Revision: A Updated quantity of part 3170224 in the kit

HYDRAULIC FAN SENSOR HARNESS RELOCATION 9700 (B13R)

On the vehicles affected by this bulletin, reroute the engine cooling fan speed sensor harness to avoid damage.

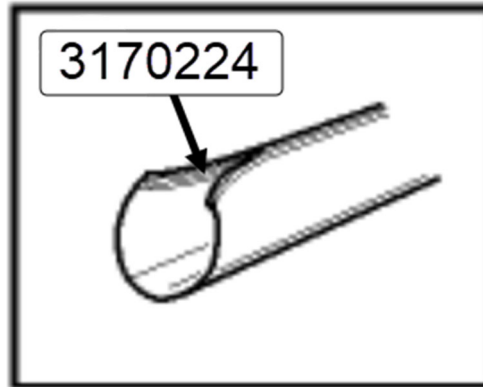
- 3) Cut cable-ties and remove the harness from its routing below the lower intercooler connection.

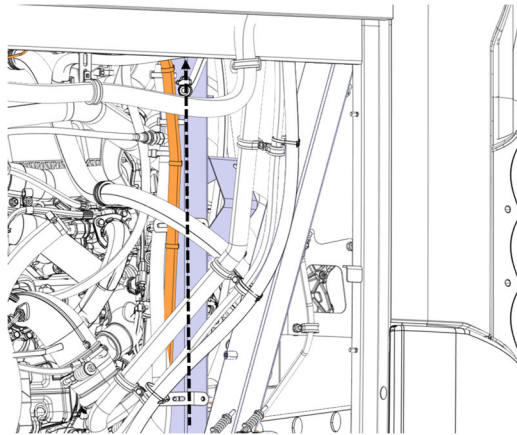
- 4) Inspect the harness branch for damage caused by contact wear. If the harness is damaged, repair it as necessary by cutting away the damaged section, and soldering or splicing the wires together to restore continuity.
- 5) Install zipper tube 3170224 over the sensor harness to protect it.

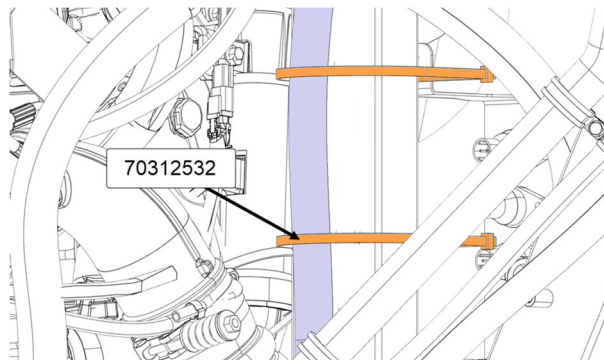
- 6) Reroute the electrical harness over to the left-hand side vertical structure fence element of the chassis.

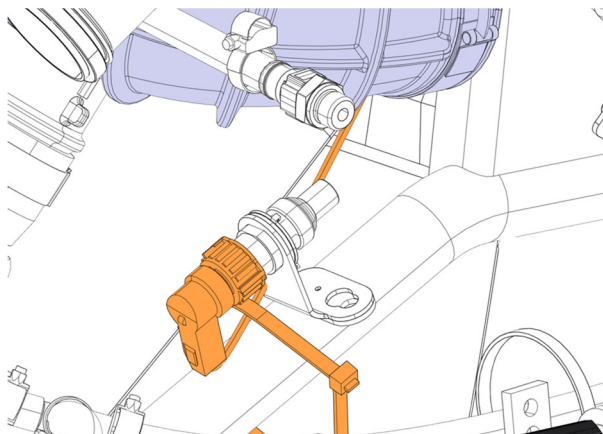
- 7) Use new cable ties 70312532 to secure the sensor harness along its new routing.
